TM 11-2241
TO 31R1-2URR-201
C 3

FREQUENCY SHIFT CONVERTERS CV-116/URR, CV-116A/URR,
CV-116B/URR AND CV-116C/URR

TM 11-2241
TO 31R1-2URR-201
CHANGES NO. 3

TM 11-2241
TO 31R1-2URR-201 }
CHANGES No. 2 }

Figure 27.1. (Added) Frequency Shift Converter CV-116C/URR, simplified loop current circuit.

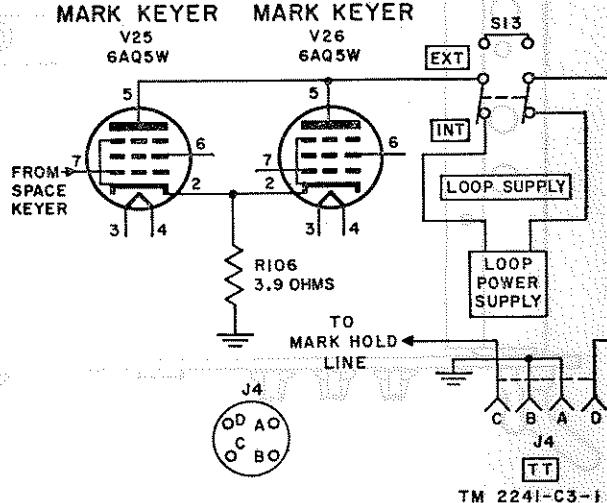
c.1. (Added) In Frequency Shift Converter CV-116C/URR, LOOP SUPPLY switch S13

(fig. 27.1) is used to connect either the internal CV-116C/URR, rear of front panel. Inter- or an external loop power supply in the circuit. change meter call-outs M2 and M3.

Figure 46.2. (Added) Frequency Shift Converter CV-116C/URR, LOOP SUPPLY switch S13.

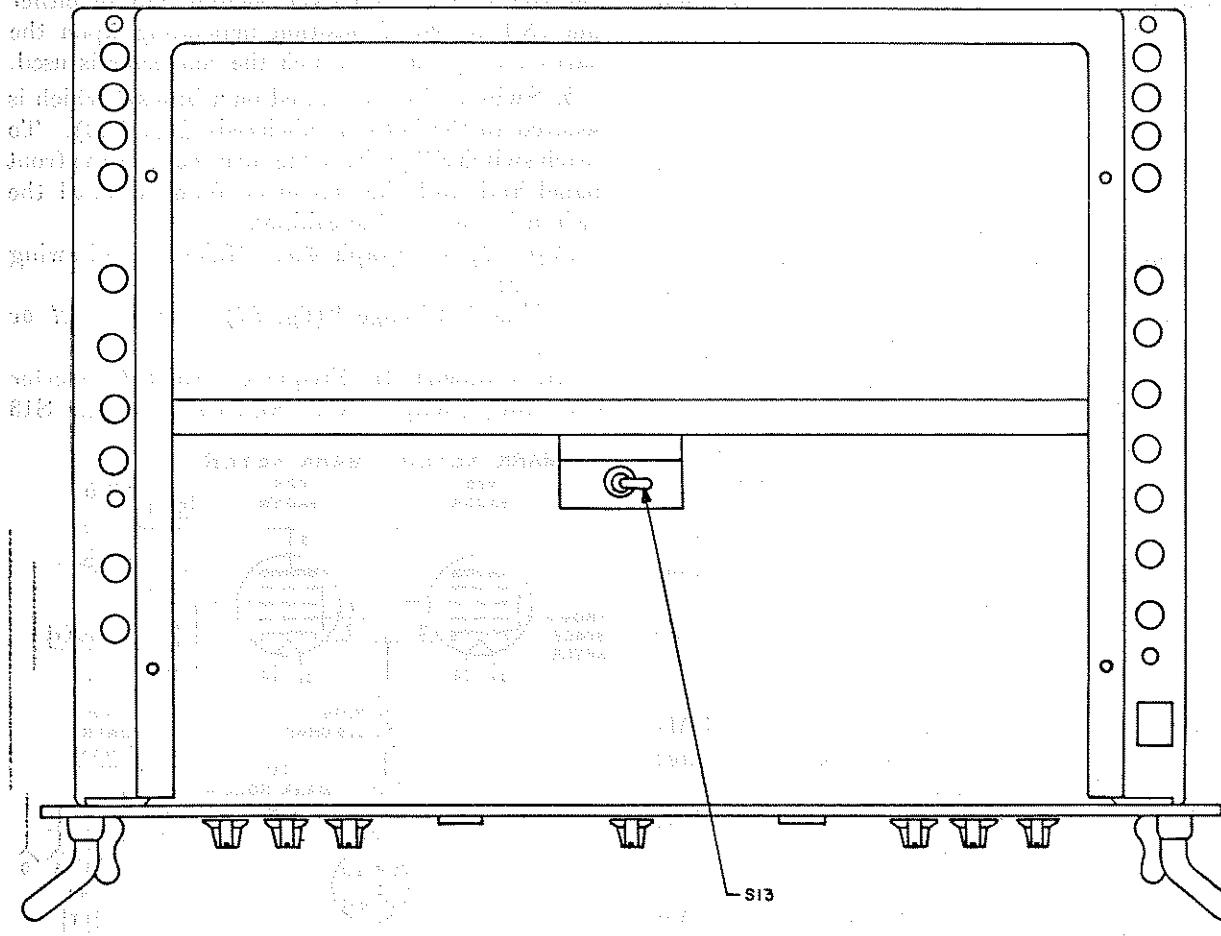
b. Switch S13 is mounted on a bracket which is secured to the bottom subchassis (fig. 46.2). To reach switch S13, release the turn-locks on the front panel and pull the converter forward until the switch is clear of the cabinet.

12. IN FREQUENCY SHIFT CONVERTER CV-116C/URR, SWITCH S13 HAS BEEN ADDED.

Figure 46.1 (Added) Frequency Shift Converters CV-116A/URR and CV-116B/URR, bottom view, location of added capacitor C96.

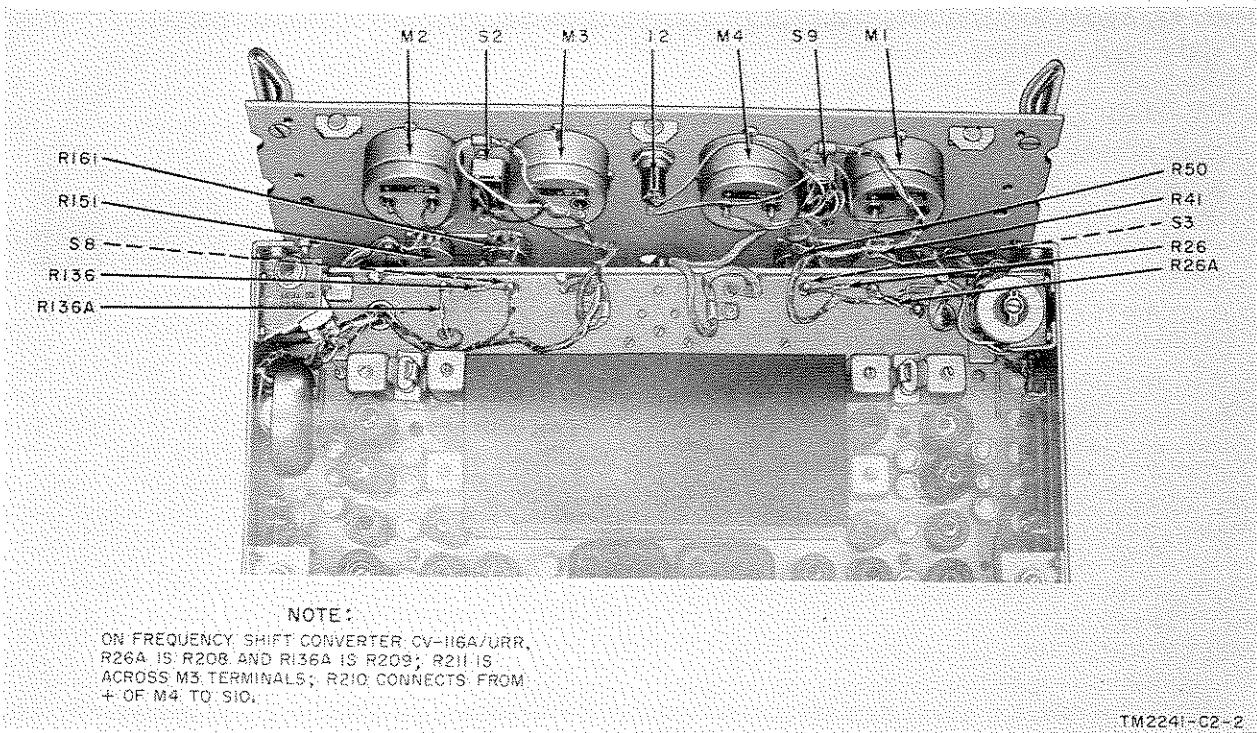
d. (Added) In Frequency Shift Converter CV-116B/URR, capacitor C96 (.068 μ f) has been added from terminal 3 of filter Z5 to ground. Capacitors C92 and C93 are deleted. Resistors R202 and R203 are deleted and direct wire connections are made in place of the resistors.

Page 53, paragraph 55a(1). Last line. Change "fig. 46)" to read: (fig. 46 or 46.1).
